SERVICE TECHNICAL INFORMATION

ONE POINT REPAIR

REF. NO. : SI-97-019
CUSTOMER RELATION SERVICE DIV.

MODELS : Z-M2800/M2900/VM280/VM290, NSX-F9/V800/V900
SUBJECT : No power/Sound Distortion due to power IC defect.
CONTENTS : Due to power IC(STK-419-***defect, it is caused to no power or sound distortion. It requires to modify following contents to all repair items when replace in the above mentioned power IC.

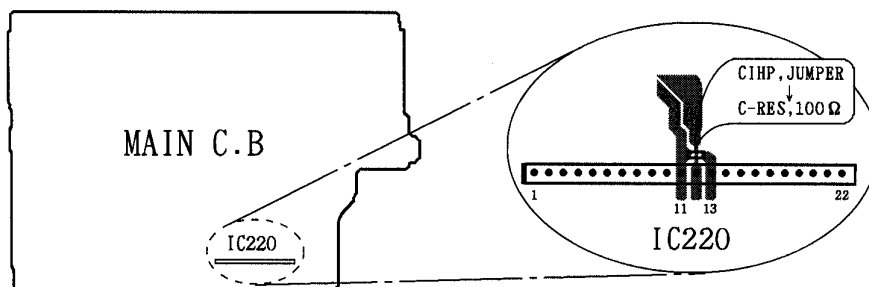
MEMO : This modification is required to do all in the above mentioned models for repair even power IC is not damaged.

REMEDY : To replace parts from chip jumper to chip resistor, $100\Omega \cdot 1/8W$, between pin① and ⑬ of IC220.
